Specialist Planner Referral (ADG)

TO: PATCH PLANNING – Independent planning consultant
FROM: ELLE DURRANT - SENIOR DEVELOPMENT OFFICER (PLANNING)
DATE: 20 NOVEMBER 2024
DA NO: DA2023/00419

PROPERTY: 121 HUNTER STREET NEWCASTLE
PROPOSAL Demolition of existing buildings & the erection of a mixed-use development consisting of retail premises, shop top housing and residential flat buildings with 195 dwellings.

Extract of apartment 3N-01.01, separation distances between south facing 'BED 3' and 'LIVING' windows, and the north facing habitable room windows of Building 3 South, shown blue (source: 'FLOOR PLAN - 3N&3S - LEVEL 01', drawing DA-3N&3S-1006, revision G, dated 15/10/2024)

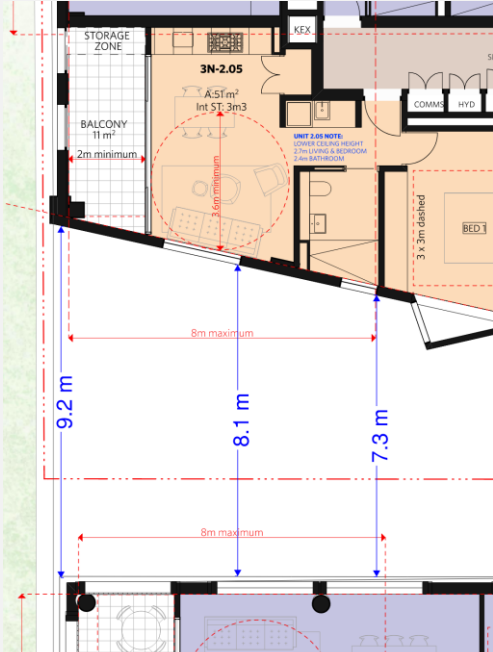
At Level 01, the south facing 'BED 3' and 'LIVING' windows of apartment 3N-01.01 are separated from the north facing habitable room windows of Building 3 South a distance of 7.3m and 8.1m respectively. However, a minimum separation distance of 12m is required between buildings on the same site at this height (6m for habitable rooms + 6m for habitable rooms).

development to amend to the south facing windows of apartment 3N-01.01 and 3N-02.01 to ensure suitable visual privacy is provided.

Extract of section showing separation distances between existing neighbour No.16-18 Newcomen Street on the left, proposed Laing lane café in the middle, and proposed Building 4 South on the right (source: East End Stage 3 & 4 Design Report, version 02, dated 29/10/2024, page 122)

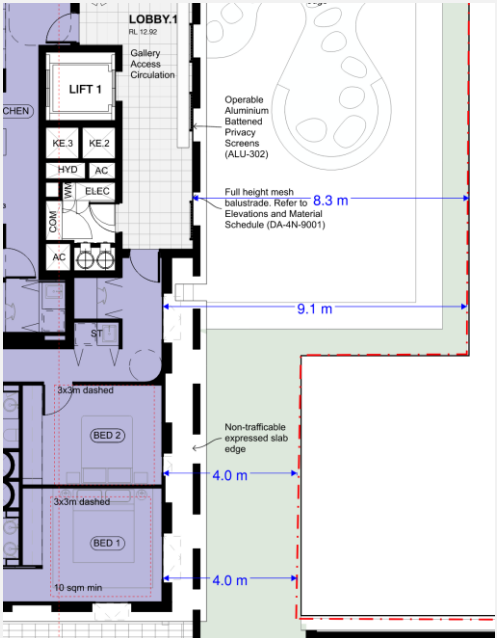
The design measures at this interface are considered to effectively achieve suitable visual privacy. As such, the proposed separation at this height is considered acceptable despite the separation distance between building on the same site being numerically less than the separation distances described in this part of the ADG.

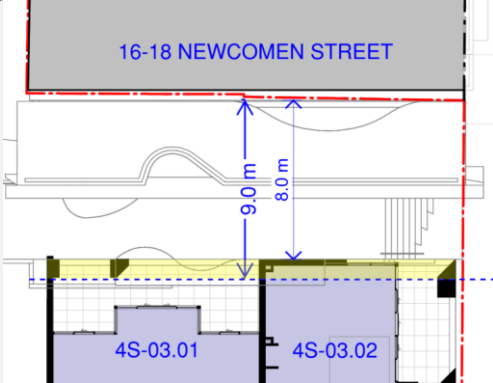
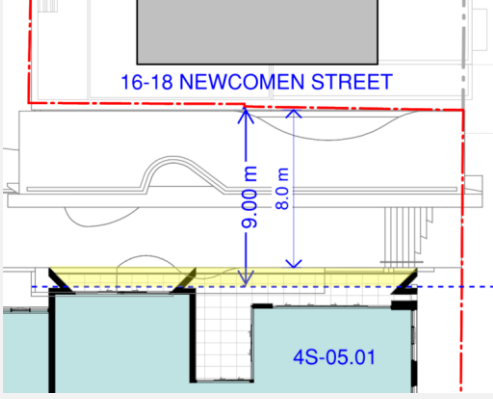
Whilst not required to satisfy the minimum building separation distances described in this part of the ADG as a blank wall does not require any setback, the design of the Laing Lane Café building aims to maintain the amenity of the existing non-compliant neighbour at No.16-18 Newcomen Street. Specifically, the northern façade at the 'Upper' level incorporates a curved sculptural relief, or 'indent,' designed to address the existing south-facing windows of No. 16-18 Newcomen Street, which are only 1.85m from the shared boundary. This feature aligns with the existing setback of the Blackhall House building on the subject site which is proposed for demolition as part of the subject development application. Blackhall House, a two-story structure currently set back 1.635m from the northern boundary, has multiple habitable room windows overlooking the neighboring residential apartments.

The proposal improves neighbourly amenity by eliminating the immediate overlooking condition that exists as a result of Blackhall House's north facing habitable windows.

Extract of apartment 3N-1.01, 'BED 3' minimum width dimensioned in blue (source: 'FLOOR PLAN - 3N&3S - LEVEL 1 PLAN', drawing DA-3N&3S-1006, dated 15/10/2024)

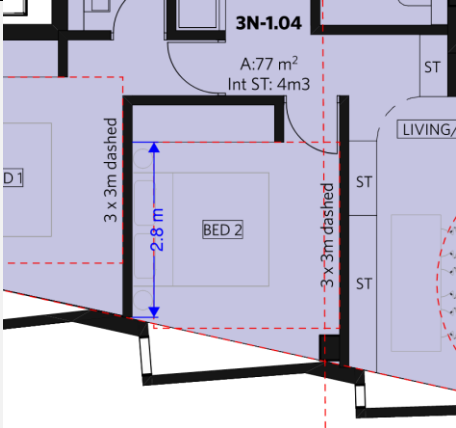
Generally, 'BED 3' of apartment 3N-101 has a minimum dimension of 3m or greater. However, a small portion falls below this standard, measuring approximately 2.8 meters (scaled from the submitted floor plans) due to the angled alignment of the south facing exterior wall.

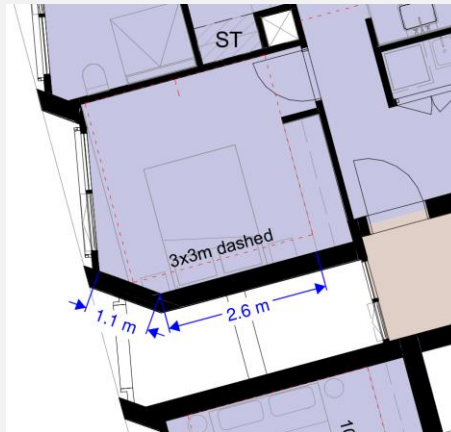
Generally, 'BED 2' of apartments 3N-104, and 3N-2.04 have a minimum dimension of 3m or greater. However, a small portion falls below this standard, measuring approximately 2.8 meters (scaled from the submitted floor plans) due to the angled alignment of the south facing exterior wall.

Extract of apartment 3W-01.04, second bedroom minimum width dimensioned in blue (source:

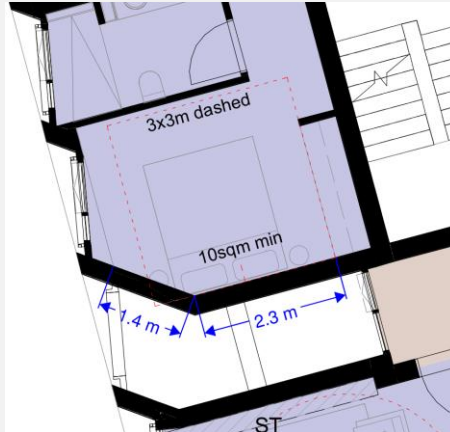
Generally, the second bedroom of these apartments have a minimum dimension of 3m or greater. However, a small portion falls below this standard, measuring approximately 2 meters (scaled from the submitted floor plans), due to the angled concrete blades which are a key feature of the façade design and expression.

Extract of apartment 3N-03.02, balcony depth dimensioned in blue (source: 'FLOOR PLAN - 4N - LEVEL 03', drawing DA-4N-1004, dated 15/10/2024)

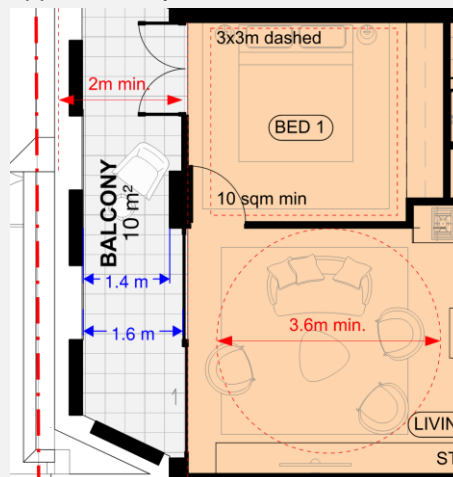
<p>2 bedroom apartments has been achieved. For 3+ bedroom apartments, the floor plans show a red dashed line set 2.4 meters from the exterior wall, confirming where compliance with the minimum depth requirement has been achieved. Additionally, the area of each balcony is clearly labeled on the floor plans, confirming each primary balcony meets the minimum area required for the number of bedrooms served.</p> <p>(see architectural floor plan drawings DA-4N-1002 to DA-4N-1010 dated 15/10/2024, for details)</p> <p>The design guidance provided for this objective acknowledges that balcony use may be limited in some proposals, and in these situations other amenity benefits for occupants should be provided in the apartment, or in the development, or both. The design drawings have suitably demonstrated how; (1) the site constraints (adaptive reuse of heritage contributory buildings) may limit balcony use and, (2) the proposal has been designed having regard to optimizing residential amenity for occupants (greater than minimum internal areas for apartments, and high-quality public and communal open space). Furthermore, the design drawings have suitably demonstrated the apartment balconies are well designed by showing the useability and functionality of the space with realistically scaled furniture layouts and circulation spaces, despite the non-compliance.</p> <p>The non-compliance proposed can be accepted on a balance view regarding both minimum balcony depths and areas. As a result, the proposal is considered to comply with the design guidance for this objective. Nevertheless, the non-compliant apartments are detailed below:</p> <p><u>APARTMENT 4N-2.02, 4N-2.03, 4N-3.02, 4N-3.03, 4N-4.02, and 4N-4.03.</u></p> <p>The submitted architectural floor plans label the primary balcony as 11sqm, which complies with the minimum area required for 2 bedroom apartments (10sqm).</p> <p>However, the red dashed line, set 2m from the external wall, illustrates that the minimum balcony depth of 2m required for a 2 bedroom apartment is not achieved. Upon scaling from the submitted floor plans, the balcony depth ranges from approximately 1.7m to 1.9m</p>

Extract of apartment 3N-03.04, balcony depth dimensioned in blue (source: 'FLOOR PLAN - 4N - LEVEL 03', drawing DA-4N-1004, dated 15/10/2024)

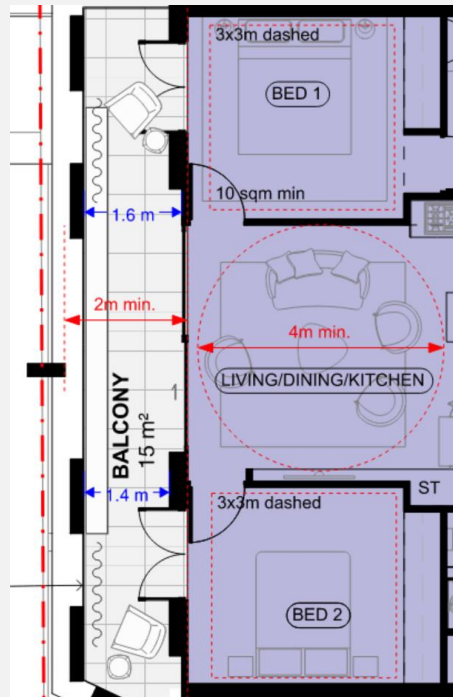
The submitted architectural floor plans label the primary balcony as 10sqm, which complies with the minimum area required for 1 bedroom apartments (8sqm).

However, the red dashed line, set 2m from the external wall, illustrates that the minimum balcony depth of 2m required for a 1 bedroom apartment is not achieved. Upon scaling from the submitted floor plans, the balcony depth ranges from approximately 1.4m to 1.6m

Extract of apartment 3N-03.05, balcony depth dimensioned in blue (source: 'FLOOR PLAN - 4N - LEVEL 03', drawing DA-4N-1004, dated 15/10/2024)

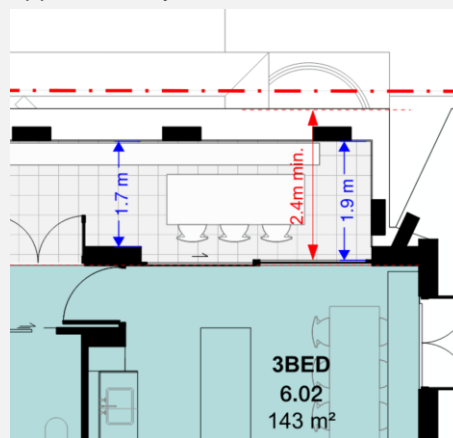
However, the red dashed line, set 2m from the external wall, illustrates that the minimum balcony depth of 2m required for

a 2 bedroom apartment is not achieved. Upon scaling from the submitted floor plans, the balcony depth ranges from approximately 1.4m to 1.6m
